605 N BOUNDARY STREET

Construct rear addition;
remove and replace rear deck;
install pergola over deck;
expand side porch and construct
new roof; changes to existing
windows and door;
install column on front porch pier

APPLICATION FOR A CERTIFICATE OF APPROPRIATENESS – STAFF REPORT

COA-0197-2018 605 N BOUNDARY STREET

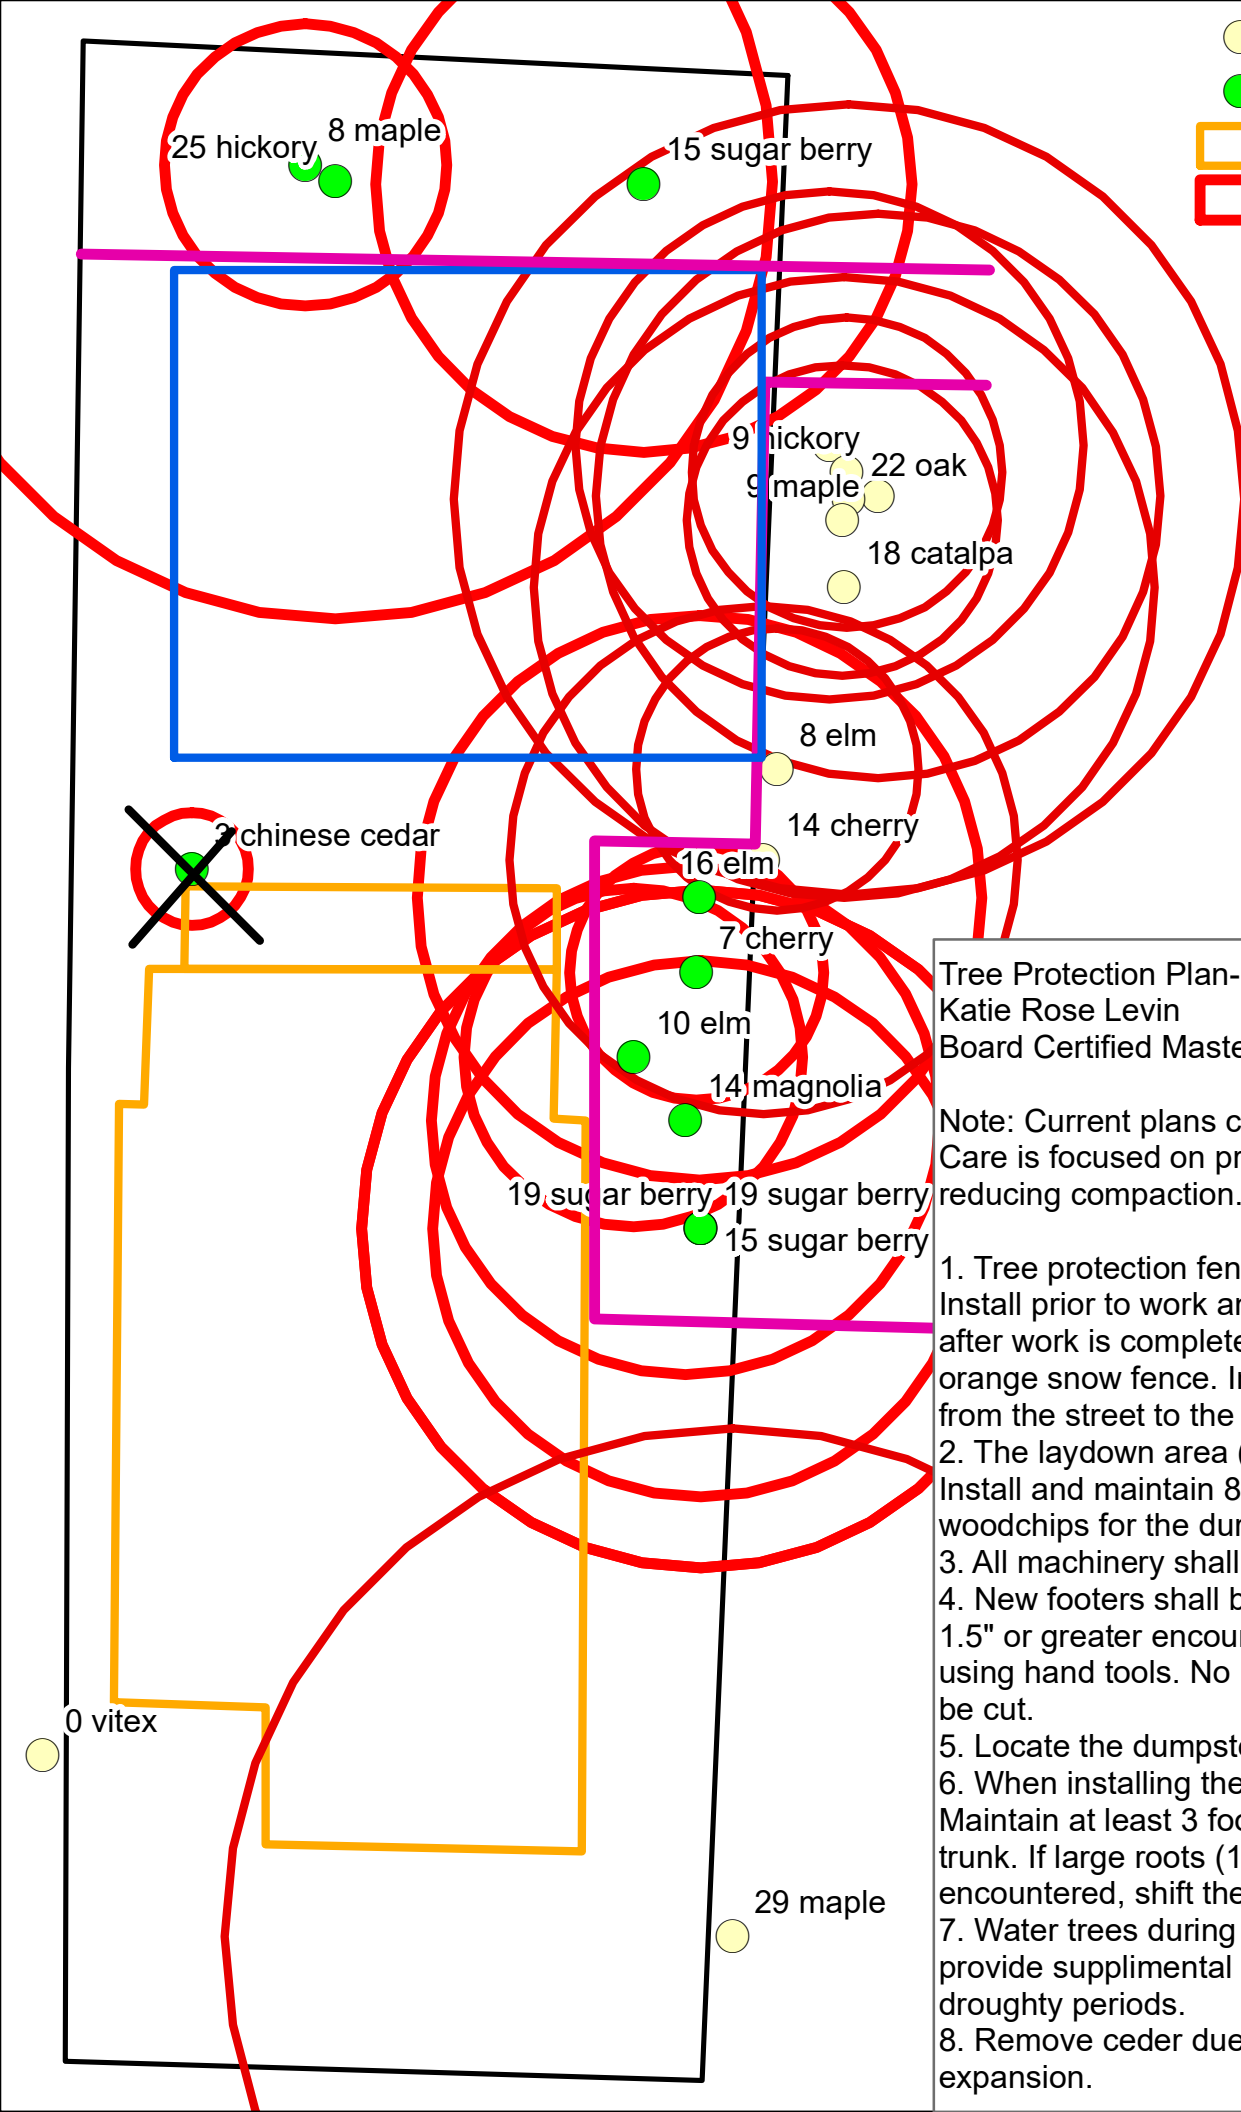
- 3* No trees over 8" DBH are proposed for removal. A tree protection plan prepared by an ISA certified arborist was provided showing the locations, DBH, species and critical root zones of trees on the property; however, it is unclear from the tree protection plan how or whether the tree protection fencing is enclosed along the Elm Street right-of-way. The plan also does not show the footprint of the proposed addition, nor is it clear where the driveway is located.

- 3* A tree protection plan was provided showing the locations, DBH, species and critical root zones of trees on the property. The tree protection plan does not include the location of the proposed fence and gates; therefore, it is difficult to assess whether the tree protection measures are sufficient for this component of the project.

3. That details and specifications for the following be provided to and approved by staff prior to issuance of the blue placard:
 - a. An updated tree protection plan showing how the tree protection fencing is enclosed on the Elm Street side, as well as the location of the proposed addition, fence and gates, and the location of the existing driveway.
